CITY PLAN COMMISSION STAFF REPORT

PROJECT NAME Price Brothers Expansion

CD-CPC-2022-00074- Development Plan

Case Number: CD-CPC-2022-00074 Project: Price Brothers Expansion

LS-1 LANDSCAPE PLAN

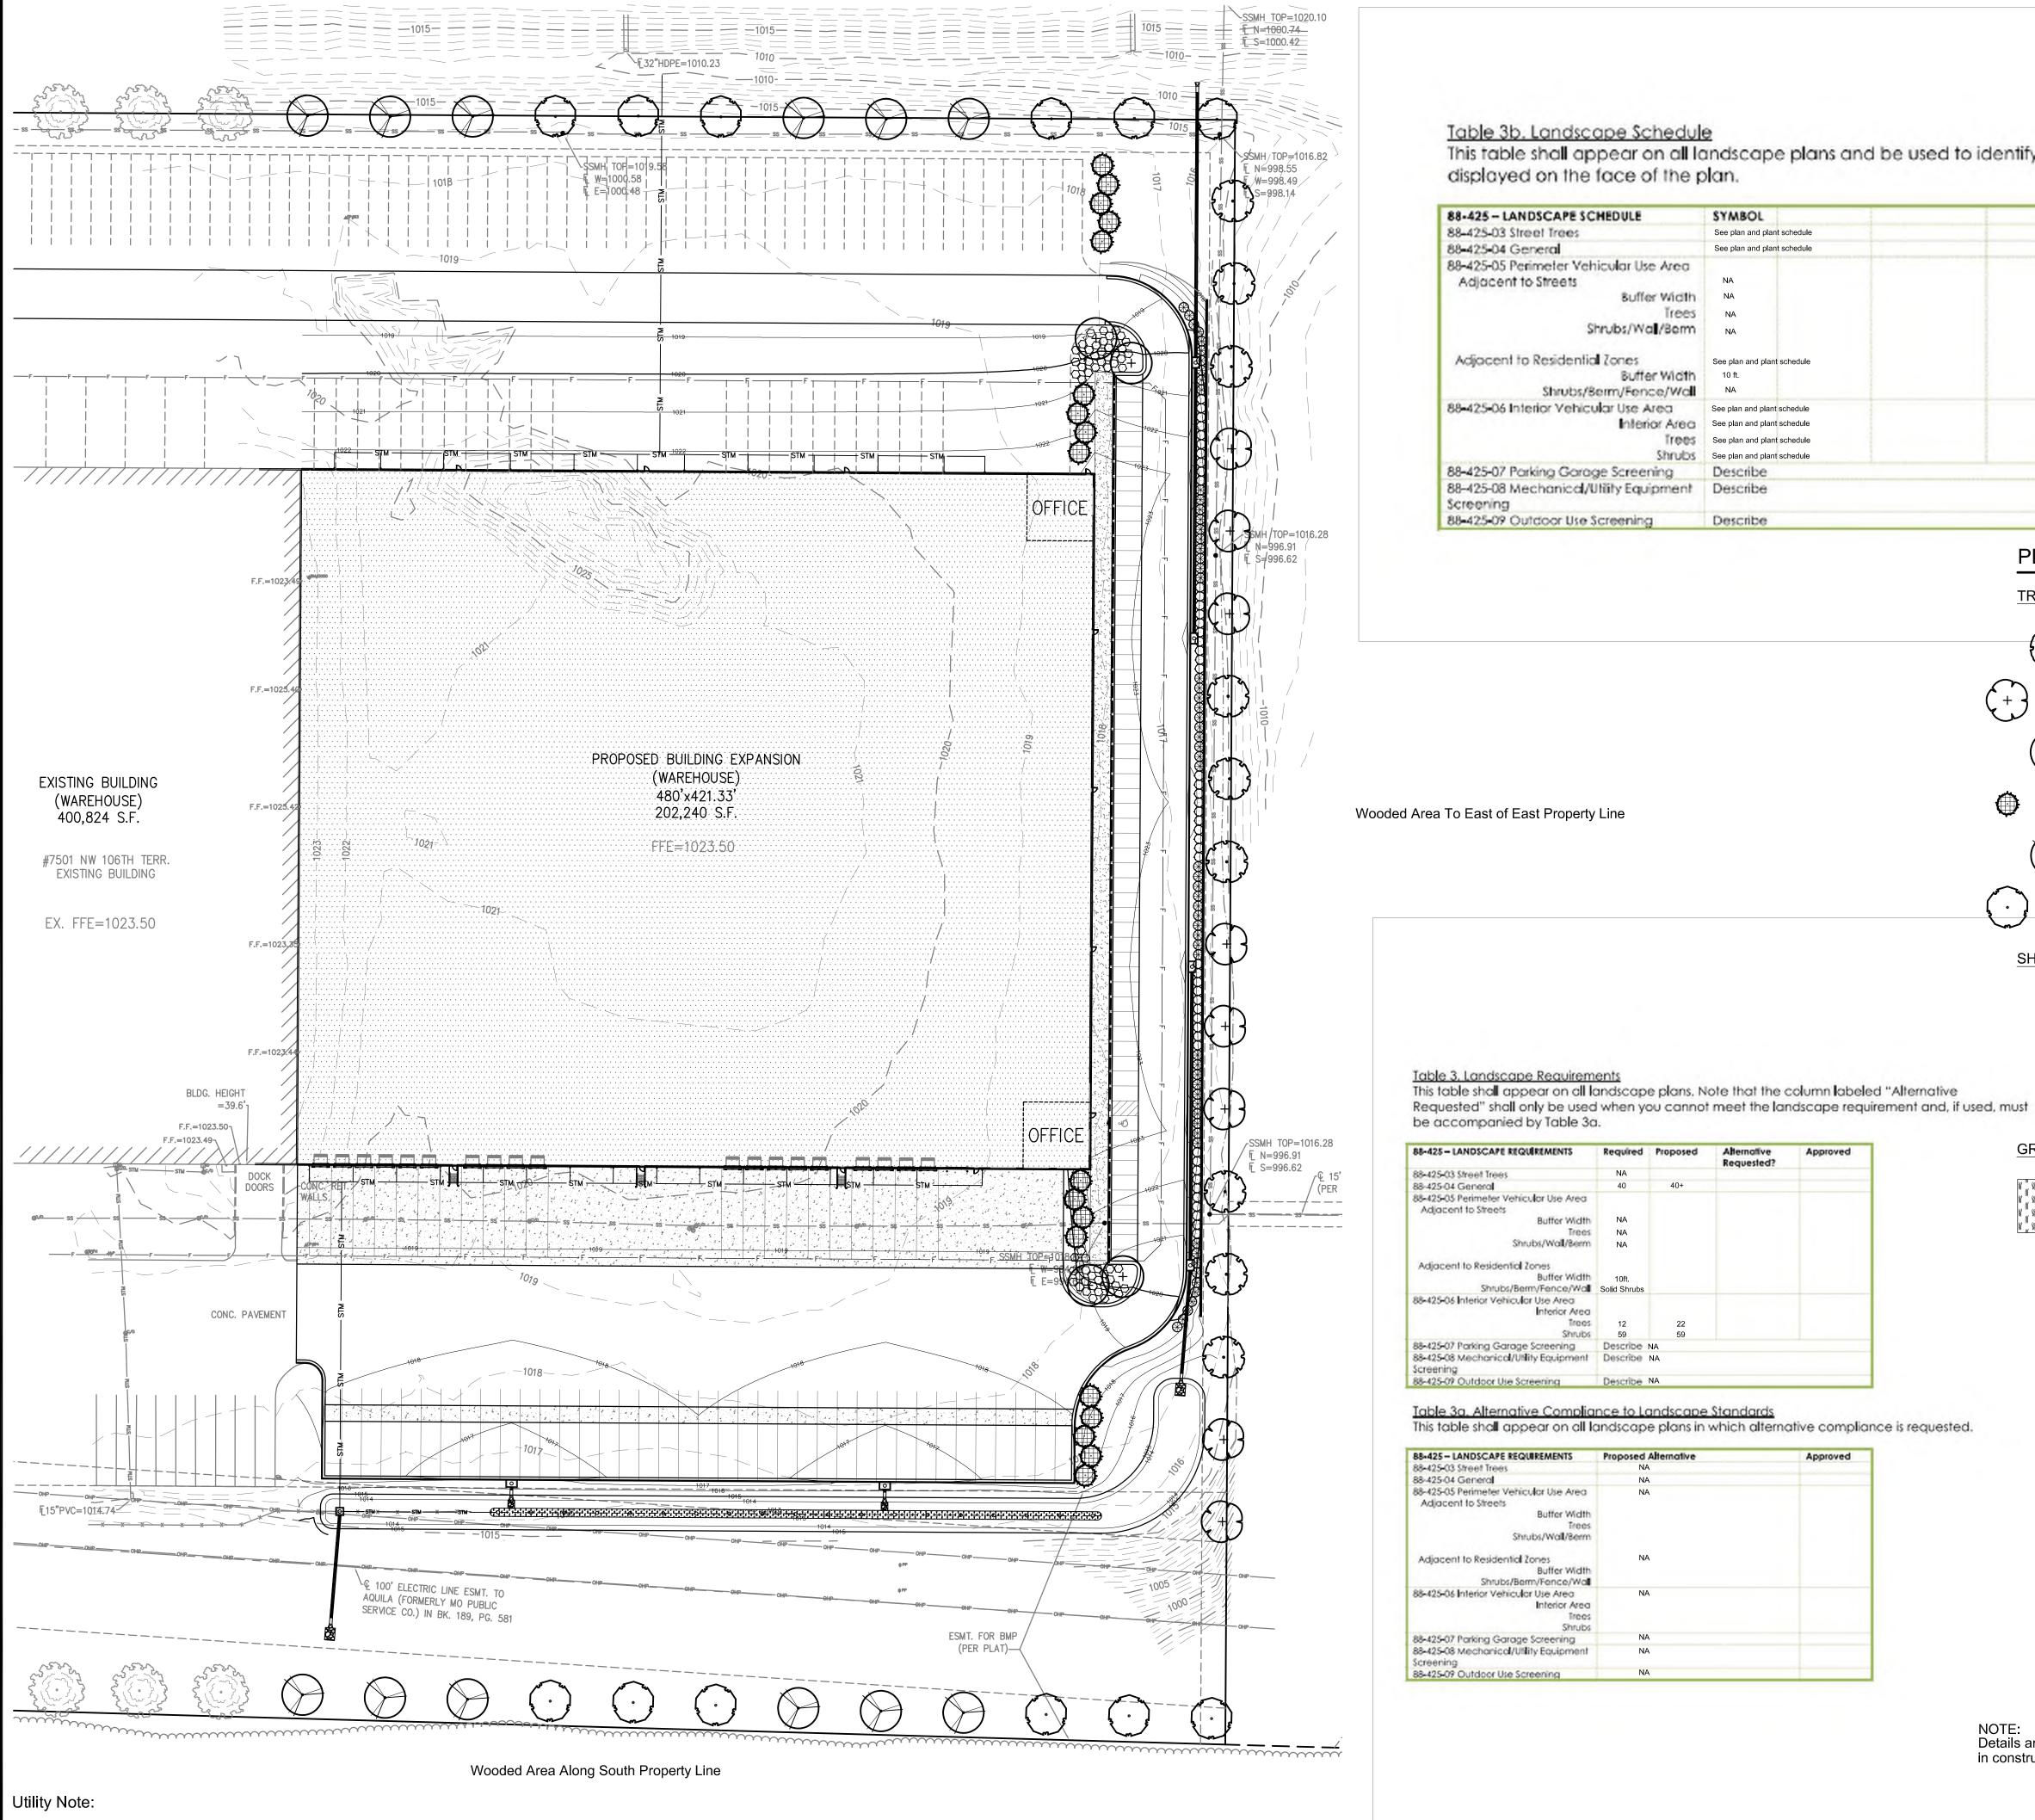
There are no trees on the site. Staff recommends that street trees be provided.
